Project Title
**Paddington Green
Police Station**

Stage 1 Road Safety Audit & Designers Response

**Paddington Green Police Station, Newcastle Place, City of Westminster
Proposed Highway Works
Stage 1 Road Safety Audit**

Figure 1 - Problem Location Points

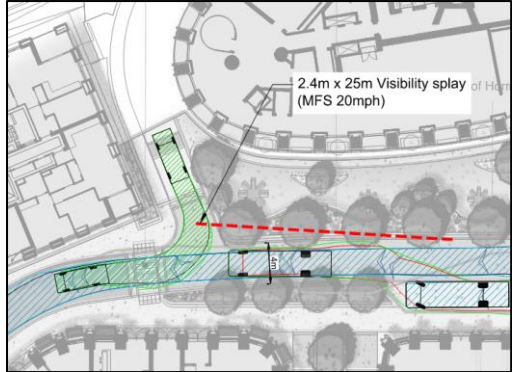
- Issue 1 - Location of bollards on Newcastle Place
- Issue 2 - Visibility splay at internal priority junction on Newcastle Place
- Issue 3 - Visibility splay at Newcastle Place / Paddington Green

Problem RSA Ref No.	Location	RSA Comment	RSA Recommendation	Problem Accepted Y/N	Recommendation Accepted Y/N	Designer’s Response
2.3.1	1	<p>Location of bollards on Newcastle Place</p> <p><i>“Lack of detail of current proposals to control vehicular access to Newcastle Place from Edgware Road could result in delivery vehicles and any taxi/car drop vehicles being unable to completely clear the Edgware Road carriageway, which could lead to a potential increased risk of side impact vehicular collisions occurring and nose to tail shunt type collisions occurring, whereby vehicle occupants could sustain personal injury.”</i></p>	<p><i>“It is Recommended that an entrance threshold area of sufficient length should be provided within Newcastle Place, thus allowing 10 metre rigid vehicles and any taxi/car drop off vehicles to be able to completely clear the Edgware Road carriageway and thus not obstruct Edgware Road northbound and south bound vehicular traffic.”</i></p>	Y	Y	<p>An allowance has been provided in the design, with the bollards set back 11.0m from the pedestrian crossing (proposed as part of TfL Edgware Road widening works), to allow a large vehicle to wait. This represents a total distance of around 20m from Edgware Road. Given the expected low number of vehicle trips, no more than one vehicle is expected to arrive at the same time and large vehicles are expected to be very occasional. The location of bollards are illustrated below.</p>

Problem RSA Ref No.	Location	RSA Comment	RSA Recommendation	Problem Accepted Y/N	Recommendation Accepted Y/N	Designer's Response
2.3.2	2	<p>Visibility splay at internal priority junction</p> <p><i>“Visibility splay at the loop road junction with Newcastle Place is likely to be impacted upon by the proposed tree planting, which could lead to a potential increased risk of side impact vehicular collisions occurring, whereby vehicle occupants could sustain personal injury.”</i></p>	<p><i>“It is Recommended that the proposed tree should be relocated, thus affording a better or improved visibility splay to the left to be achieved for vehicles emerging from the loop road and Newcastle Place. Alternatively, the proposed layout should be agreed with the Overseeing Organisation, i.e. the Local Highway Authority, Westminster City Council.”</i></p>	Y	Y	<p>The tree is at the eastern corner of the junction. The visibility splay at the internal junction has been checked and shown in the attached drawing 277685-SK-015D. An extract is provided below.</p>  <p>It is proposed that the tree is retained as part of the proposals because Manual for Streets recognises that occasional obstacles to visibility (such as street trees) that are not large enough to fully obscure a whole vehicle or a pedestrian will not have a significant impact on road safety. In addition, Murdock Wickham has confirmed that the planting in this area will not exceed 600mm in height.</p>

APPENDIX B - PROBLEM LOCATION PLAN

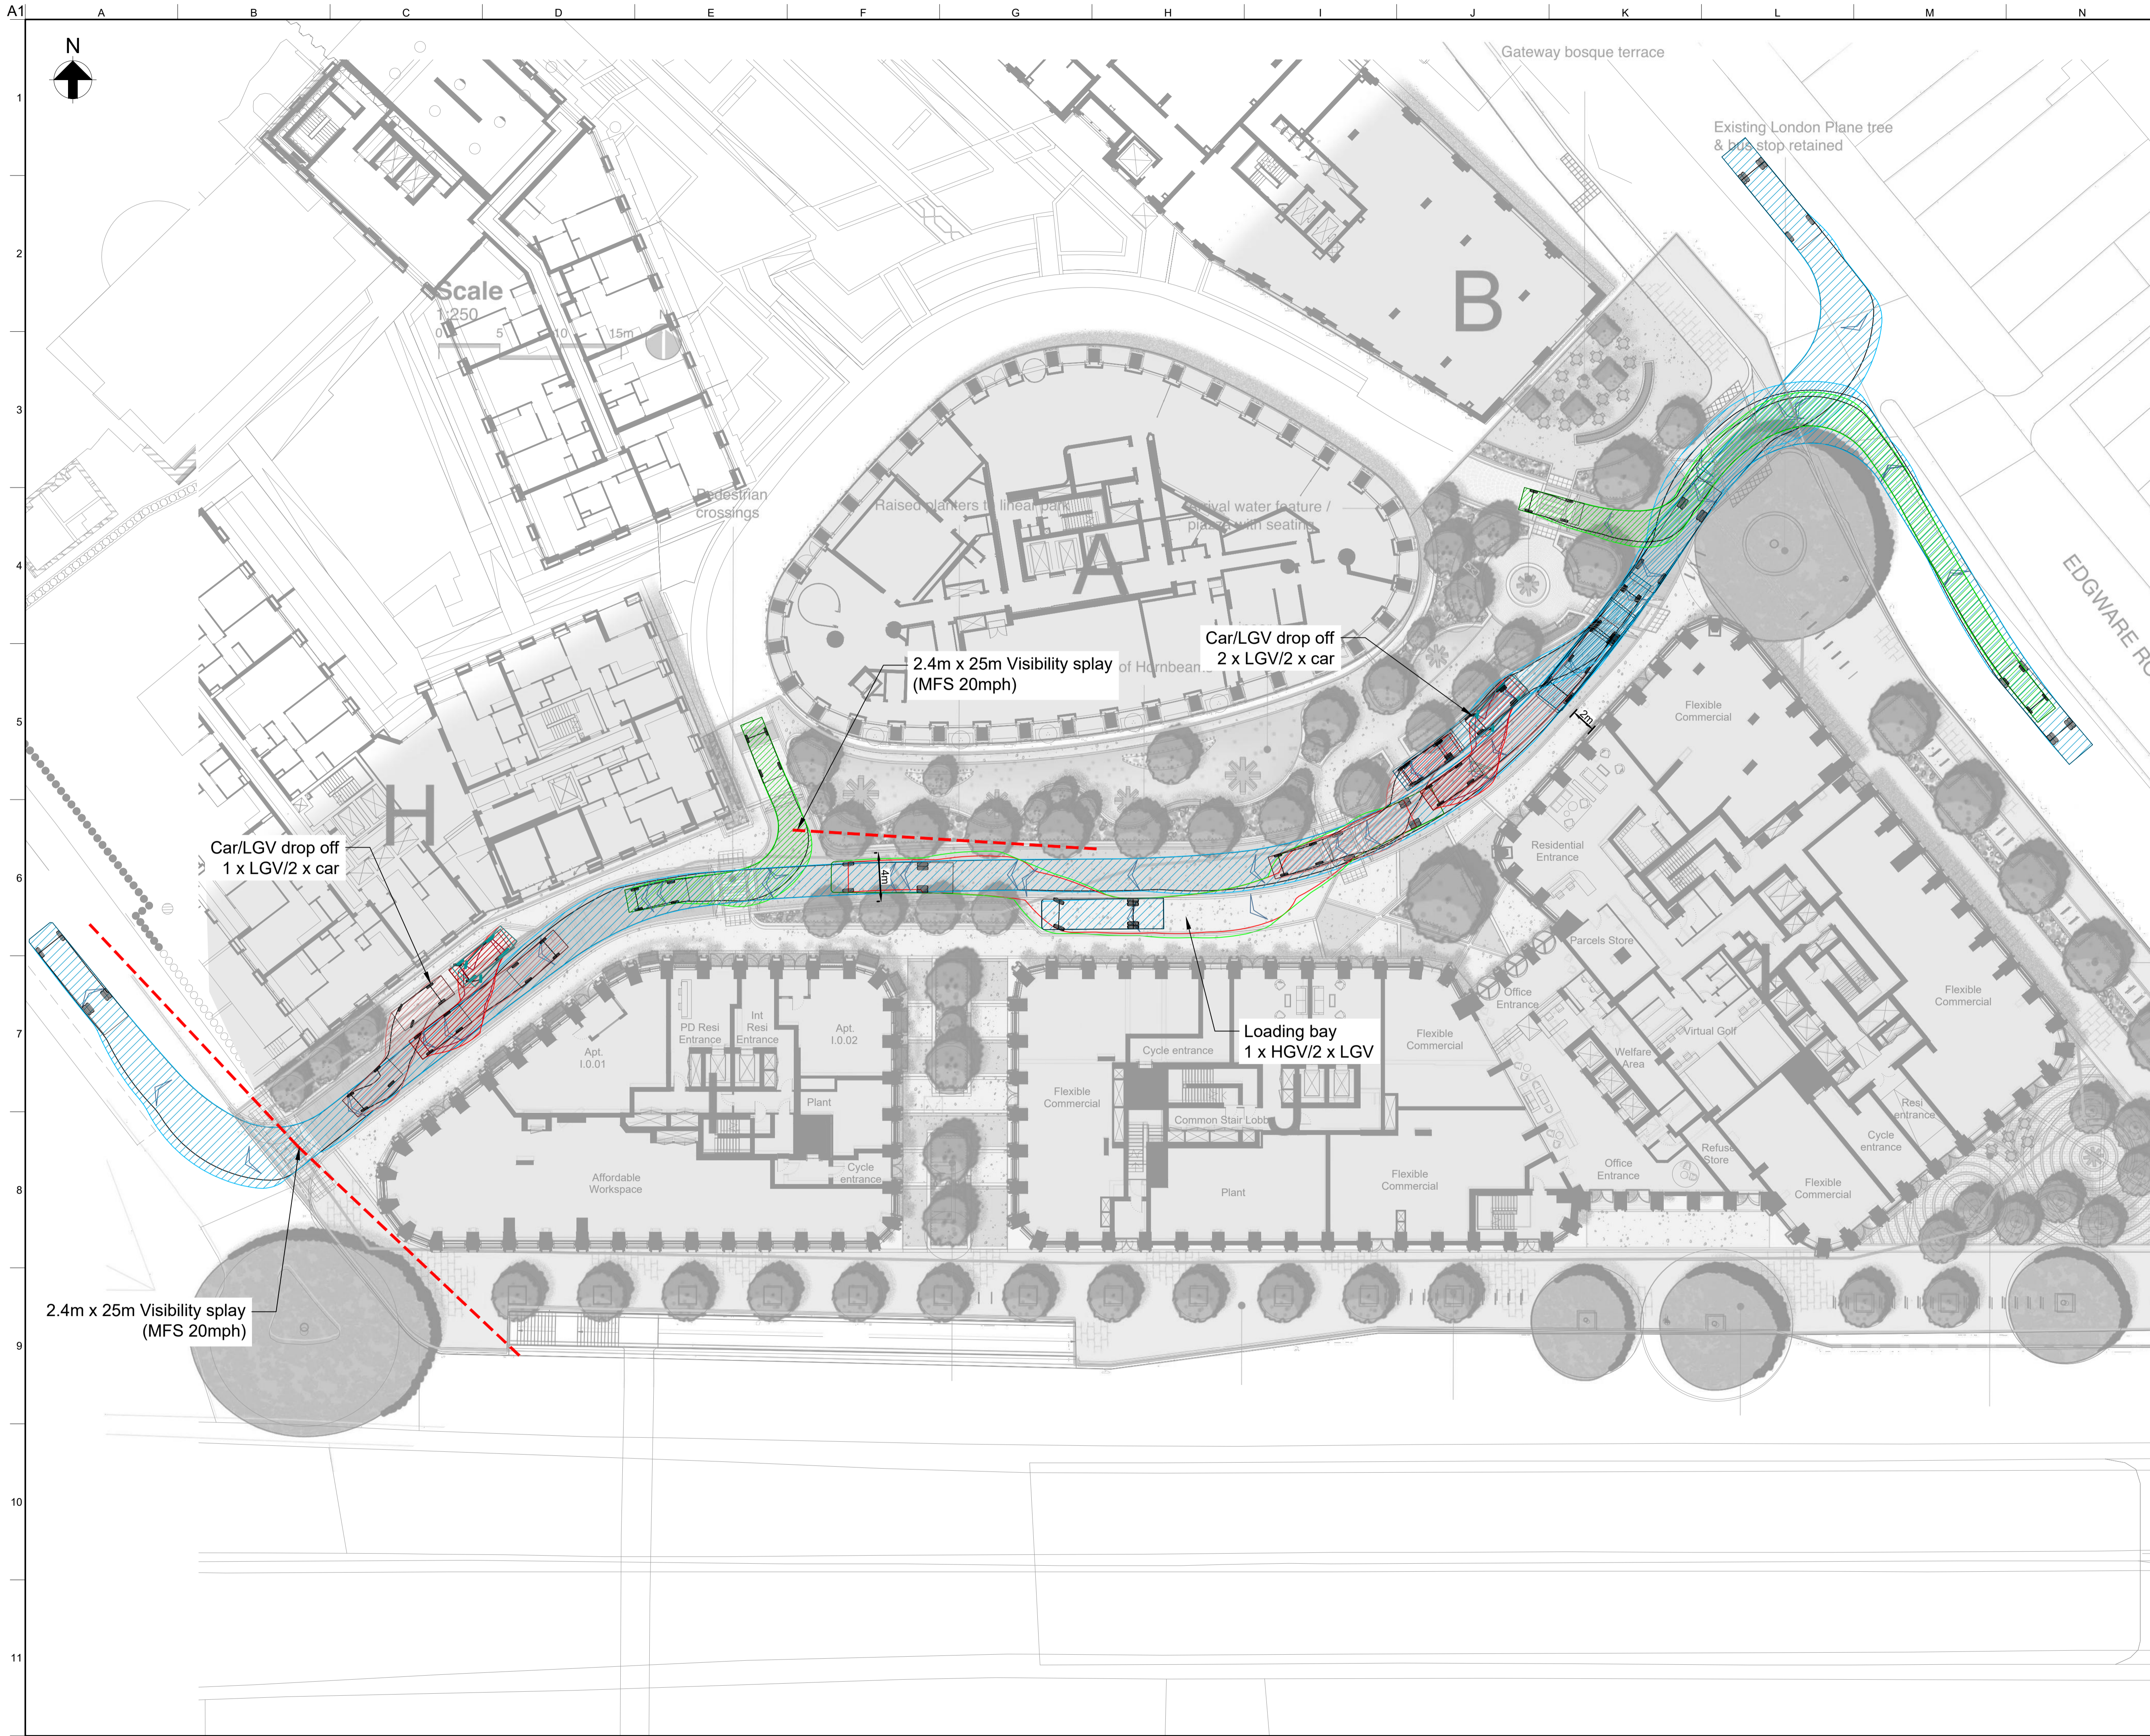
Location 1 - The Edgware Road junction with Newcastle Place (Drawing No. 277685-SK-015 Rev B).

Summary - Lack of detail of current proposals to control vehicular access to Newcastle Place from Edgware Road could result in delivery vehicles and any taxi/car drop vehicles being unable to completely clear the Edgware Road carriageway, which could lead to a potential increased risk of side impact vehicular collisions occurring and nose to tail shunt type collisions occurring, whereby vehicle occupants could sustain personal injury.

Detail - The Audit Team are advised that bollards are currently proposed on Newcastle Place in order to control vehicle access. The siting and operation of the proposed bollards to enable delivery vehicles and any taxi/car drop off to gain access to Newcastle Place from Edgware Road has not been confirmed.

Concern arises that if a 10 metre rigid delivery vehicle or any taxi/car drop off vehicle cannot completely clear the Edgware Road carriageway when seeking to enter Newcastle Place, there could be a potential increased risk of side impact vehicular collisions occurring between right turning entering vehicles and north bound Edgware Road vehicular traffic, whereby vehicle occupants could sustain personal injury.

It is Recommended that an entrance threshold area of sufficient length should be provided within Newcastle Place, thus allowing 10 metre rigid vehicles and any taxi/car drop off vehicles to be able to completely clear the Edgware Road carriageway and thus not obstruct Edgware Road north bound and south bound vehicular traffic.

Location 2 - The loop road junction with Newcastle Place (Drawing No. 277685-SK-015 Rev B).

Summary - Visibility splay at the loop road junction with Newcastle Place is likely to be impacted upon by the proposed tree planting, which could lead to a potential increased risk of side impact vehicular collisions occurring, whereby vehicle occupants could sustain personal injury.

Detail - The scheme drawing indicate that a proposed tree will be sited on the western side of the loop road, at its junction with Newcastle Place. Whilst a visibility splay for the junction has not been indicated, it is likely that the proposed tree may impact upon the visibility splay to the left for drivers emerging from the loop road into Newcastle Place.

It is Recommended that the proposed tree should be relocated, thus affording a better or improved visibility splay to the left to be achieved for vehicles emerging from the loop road and Newcastle Place.

Location 3 - The Newcastle Place junction with Paddington Green (Drawing No. 277685-SK-015 Rev B).

Summary - Visibility splay at the Newcastle Place junction with Paddington Green is likely to be impacted upon by the presence of the building line and proposed tree planting, which could lead to a potential increased risk of side impact vehicular collisions occurring, whereby vehicle occupants could sustain personal injury.

Detail - The scheme drawing appears to indicate that a building line will be present at the immediate rear of the eastern footway of Paddington Green, together with a proposed tree on the north eastern corner of the Newcastle Place junction with Paddington Green. Whilst a visibility splay for the junction has not been indicated, it is likely that the building line and the proposed tree may impact upon the visibility splay to the right for drivers emerging from Newcastle Place into Paddington Green.

It is Recommended that the proposed visibility splays for the Newcastle Place junction with Paddington Green should be determined, which should be added to the scheme drawings accordingly. The proposed visibility splays should be commensurate with the existing speed limit of Paddington Green and it is Recommended that physical features should not fall within the proposed visibility splays.
